1966 Corvette: Reliability Data Center Letter: Poor Release and High Pedal Effort - 1966 327 CID Corvette Engines

Your Reliability Data Center
Flint V-8 Engine Plant

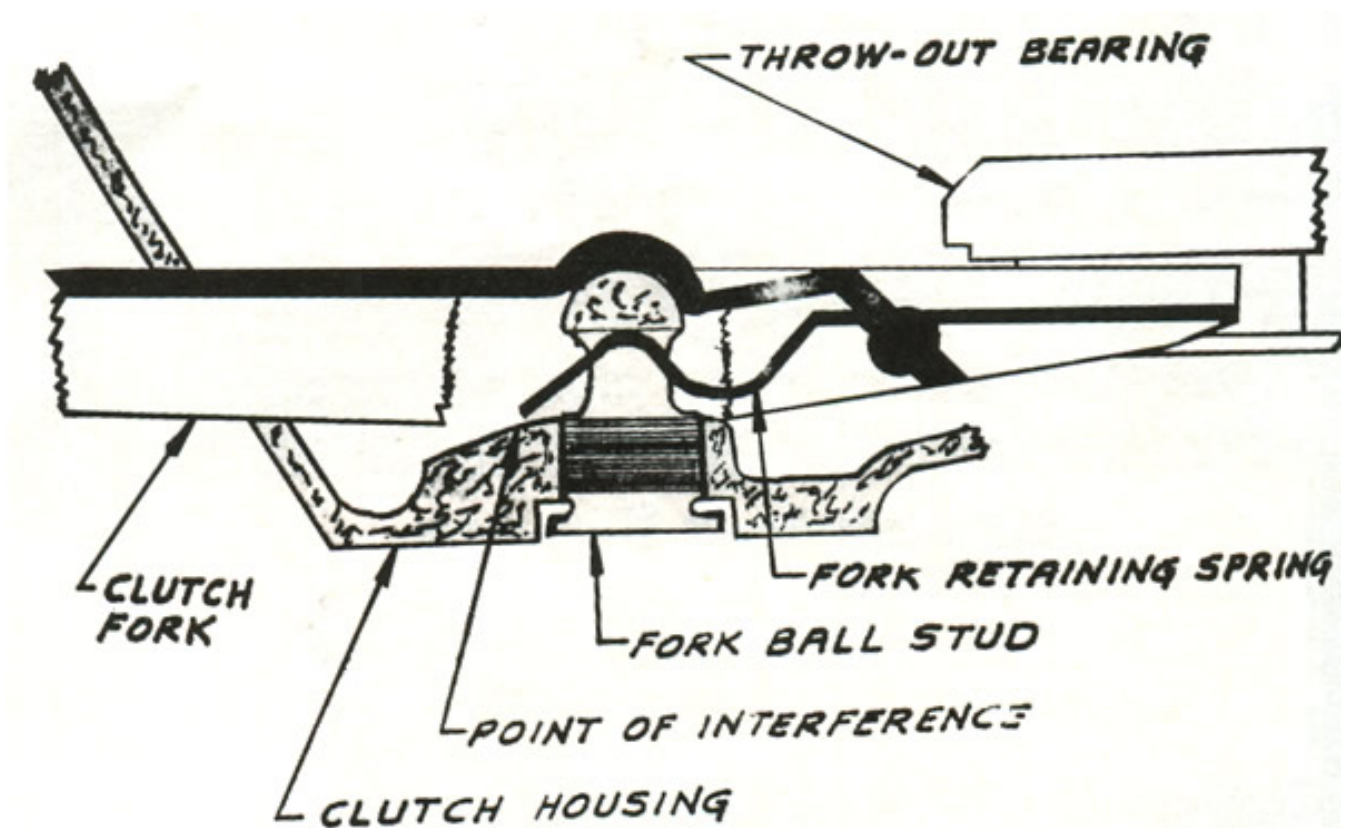
Recent investigation of poor release of clutch, high pedal effort and disc wear has isolated the condition to the clutch fork retainer tangs interfering with the clutch housing boss provided for the ball stud which causes a reduction in fork travel.

The above condition is caused by a short ball stud Part No. 3887159 which was used on 1966 327 CID Corvette engines until 4-4-66. At that time the past design ball stud part No. 3729000 was again installed and is currently being used.

In the event a complaint of high pedal effort or poor release is encountered the unit should be inspected for the above mentioned condition. (see attached illustration).

The correct ball stud Part No. 372900 has an overall length of 1 1/2 inches, the shorter stud, Part No. 3887159 is approximately 1 3/8 inches long.
